# UNITED STATES PATENT AND TRADEMARK OFFICE

APPLICATION NO.	FILING DATE	FIRST NAMED INVENTOR	ATTORNEY DOCKET NO.	CONFIRMATION NO.
10/026,477	12/27/2001	Hong Suk Yoo	8733.561.00	7762

**Office Action Summary**

## DETAILED ACTION

FIG.8D

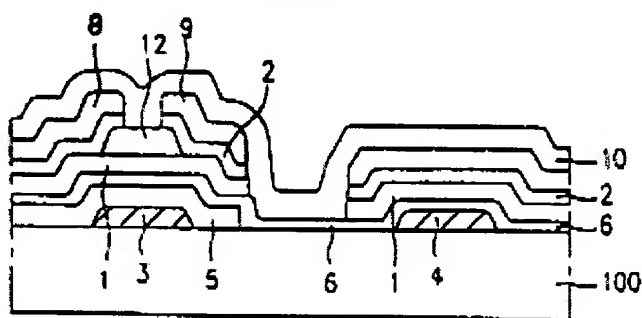
a pixel electrode (not shown, inherent to comprise functional device) electrically connected to the conductive layer (unlabeled layer between layers 2 and 10 above 4 in Figure 8D) and a drain electrode, 9, on the thin film transistor, wherein the length of the conductive layer is shorter than the length of the storage capacitor electrode, 4, per Figure 5.

As to claim 17, Moon discloses in Figure 8D the liquid crystal display device as claimed in claim 15, further comprising a semiconductor layer, 1, formed above the second insulating layer in the second region and used as a channel of the thin film transistor.

As to claim 18, Moon discloses in Figure 8D the liquid crystal display device as claimed in claim 17, further comprising a source electrode, 8, and a drain electrode, 9, opposing each other and formed above the semiconductor layer.

As to claim 19, Moon discloses in Figure 8D the liquid crystal display device as claimed in claim 18, wherein the conductive layer (unlabeled 9 between 2 and 10) is of the same material as the source and drain electrodes and formed on the second insulating layer in the first region.

As to claim 20, Moon discloses in Figure 8D the liquid crystal display device as claimed in claim 18, further comprising an ohmic contact layer, 2, formed at an interface between the source and drain electrodes and the semiconductor layer.

Art Unit: 2871

As to claim 21, Moon discloses in Figure 8D the liquid crystal display device as claimed in claim 18, further comprising a passivation layer, 10, having a contact hole and formed on an entire surface including the conductive layer and the source and drain electrodes to expose upper portions of the drain electrode and the conductive layer.

As to claim 22, Moon discloses in Figure 8D the liquid crystal display device as claimed in claim 21, wherein the pixel electrode electrically connects to the drain electrode and the conductive layer through the contact hole (inherent to a functional device and obvious to those having ordinary skill in the art given the other embodiments of Moon).

**Figure 7A**

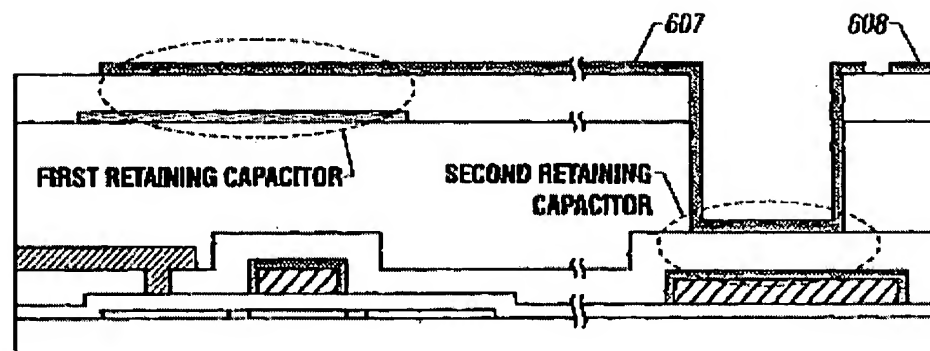
Yamazaki is evidence that workers of ordinary skill in the art would find the reason, suggestion, or motivation to make the conductive layer width shorter [portion of 607 close to electrode 603] than the width of the storage capacitor electrode in order to

maximize aperture ratio while still achieving needed capacitance with a thinner insulating layer [removed portions of 317 and 315].

Therefore, it would have been obvious to one having ordinary skill in the art at the time the invention was made to modify the invention with a conductive layer width shorter [portion of 607 close to electrode 603] than the width of the storage capacitor electrode in order to maximize aperture ratio while still achieving needed capacitance with a thinner insulating layer [removed portions of 317 and 315].

FIG.2

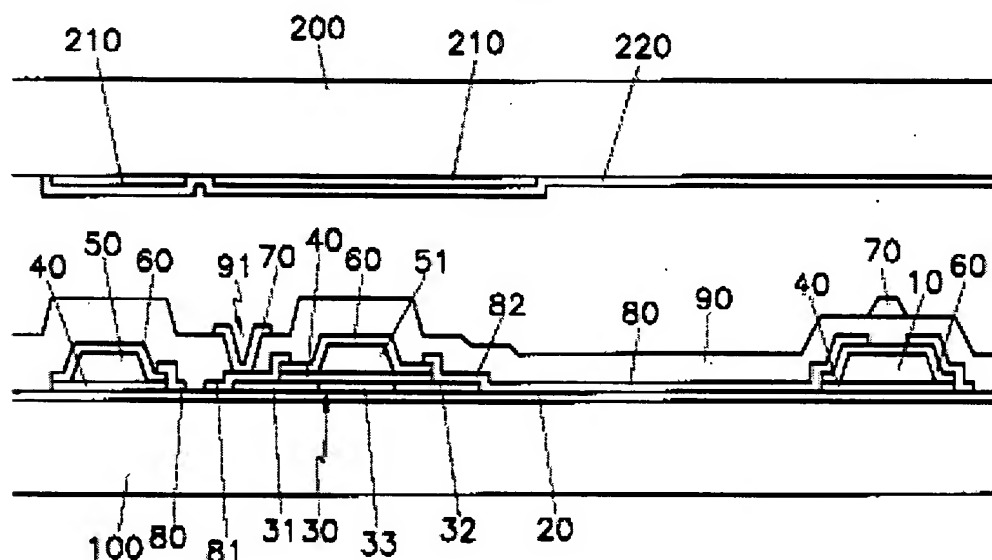
For example, Hwang teaches in the background of the invention, and in the first preferred embodiment, a second substrate, 200, comprising a plurality of Red (R), green (G), and blue (B) color filter patterns (col. 1, lines 26-33 and col. 2, lines 22-28; and Figure 2) for displaying colors; a black matrix, 210, for dividing the respective color filter patterns and for shielding light; and a common electrode, 220, for applying a voltage to the liquid crystal layer formed on the entire surface (col. 3, lines 24-26) including the black matrix and the color filter patterns, to achieve good color display performance with good contrast and good aperture ratio.

Hwang is evidence that ordinary workers in the art of liquid crystals would find the reason, suggestion, or motivation to add a second substrate comprising a plurality of Red (R), green (G), and blue (B) color filter patterns for displaying colors; a black matrix for dividing the respective color filter patterns and for shielding light; and a common electrode for applying a voltage to the liquid crystal layer formed on the entire surface including the black matrix and the color filter patterns, to achieve good color display performance with good contrast and good aperture ratio.

FIG.8D

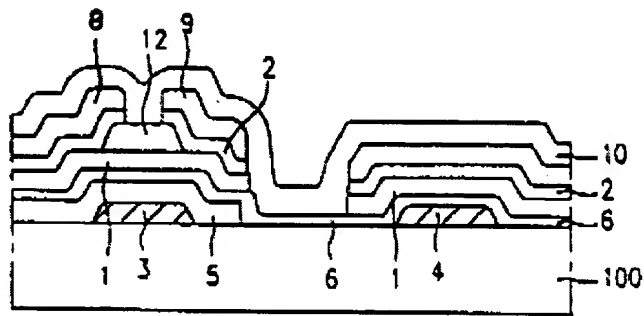
a pixel electrode (not shown, inherent to comprise functional device) electrically  
connected to the conductive layer (unlabeled layer between layers 2 and 10 above 4 in  
Figure 8D) and a drain electrode, 9, on the thin film transistor, wherein the length of the  
conductive layer is shorter than the length of the storage capacitor electrode, 4, per  
Figure 5.

As to claim 17, Moon discloses in Figure 8D the liquid crystal display device as claimed in claim 15, further comprising a semiconductor layer, 1, formed above the second insulating layer in the second region and used as a channel of the thin film transistor.

As to claim 18, Moon discloses in Figure 8D the liquid crystal display device as claimed in claim 17, further comprising a source electrode, 8, and a drain electrode, 9, opposing each other and formed above the semiconductor layer.

As to claim 19, Moon discloses in Figure 8D the liquid crystal display device as claimed in claim 18, wherein the conductive layer (unlabeled 9 between 2 and 10) is of the same material as the source and drain electrodes and formed on the second insulating layer in the first region.

As to claim 20, Moon discloses in Figure 8D the liquid crystal display device as claimed in claim 18, further comprising an ohmic contact layer, 2, formed at an interface between the source and drain electrodes and the semiconductor layer.

As to claim 21, Moon discloses in Figure 8D the liquid crystal display device as claimed in claim 18, further comprising a passivation layer, 10, having a contact hole and formed on an entire surface including the conductive layer and the source and drain electrodes to expose upper portions of the drain electrode and the conductive layer.

As to claim 22, Moon discloses in Figure 8D the liquid crystal display device as claimed in claim 21, wherein the pixel electrode electrically connects to the drain electrode and the conductive layer through the contact hole (inherent to a functional device and obvious to those having ordinary skill in the art given the other embodiments of Moon).

FIG.5

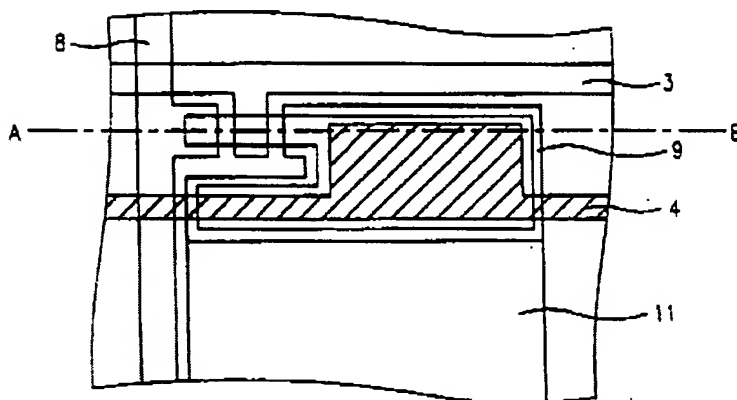
a gate electrode, 3, for the thin film transistor and a storage capacitor electrode, 4,  
spaced apart from the gate electrode [note it comprises the line running off Figure 5 on  
both sides], both formed on the first substrate;

Figure 7A

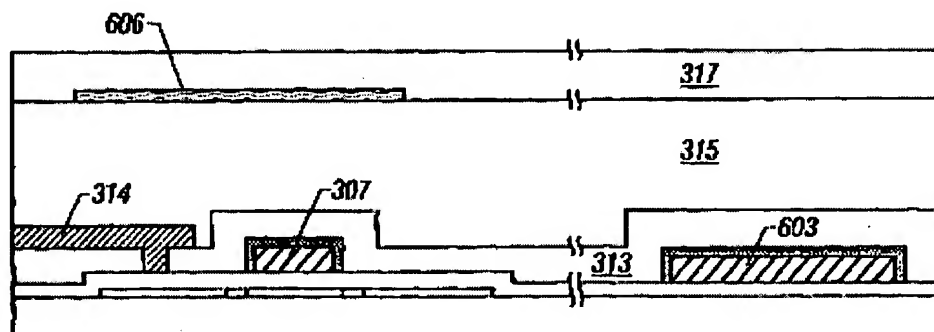
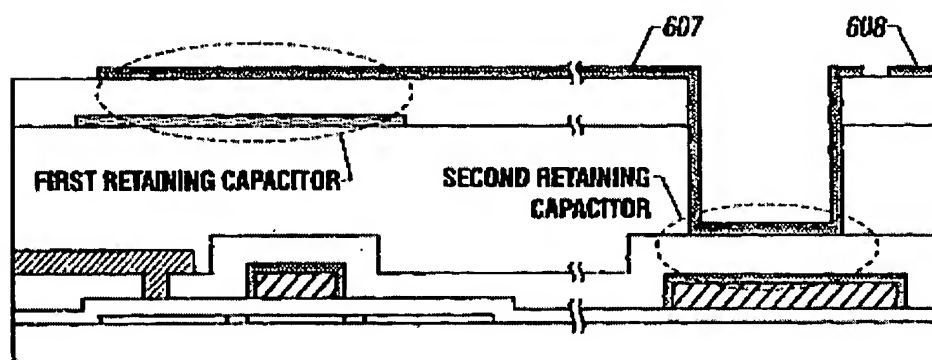
Yamazaki teaches the advantages [col. 10, lines 1-19] of making the conductive layer width shorter [portion of 607 close to electrode 603] than the width of the storage capacitor electrode in order to maximize aperture ratio while still achieving needed capacitance with a thinner insulating layer [removed portions of 317 and 315].

Yamazaki is evidence that workers of ordinary skill in the art would find the reason, suggestion, or motivation to make the conductive layer width shorter [portion of 607 close to electrode 603] than the width of the storage capacitor electrode in order to maximize aperture ratio while still achieving needed capacitance with a thinner insulating layer [removed portions of 317 and 315].

Therefore, it would have been obvious to one having ordinary skill in the art at the time the invention was made to modify the invention with a conductive layer width shorter [portion of 607 close to electrode 603] than the width of the storage capacitor

FIG.2

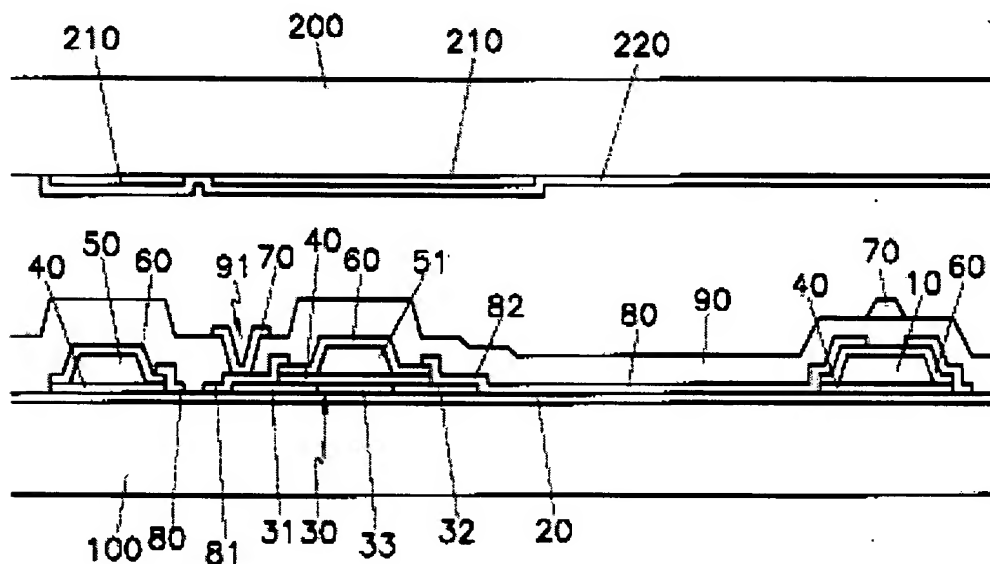
green (G), and blue (B) color filter patterns (col. 1, lines 26-33 and col. 2, lines 22-28; and Figure 2) for displaying colors; a black matrix, 210, for dividing the respective color filter patterns and for shielding light; and a common electrode, 220, for applying a voltage to the liquid crystal layer formed on the entire surface (col. 3, lines 24-26) including the black matrix and the color filter patterns, to achieve good color display performance with good contrast and good aperture ratio.

Hwang is evidence that ordinary workers in the art of liquid crystals would find the reason, suggestion, or motivation to add a second substrate comprising a plurality of Red (R), green (G), and blue (B) color filter patterns for displaying colors; a black matrix for dividing the respective color filter patterns and for shielding light; and a common electrode for applying a voltage to the liquid crystal layer formed on the entire surface
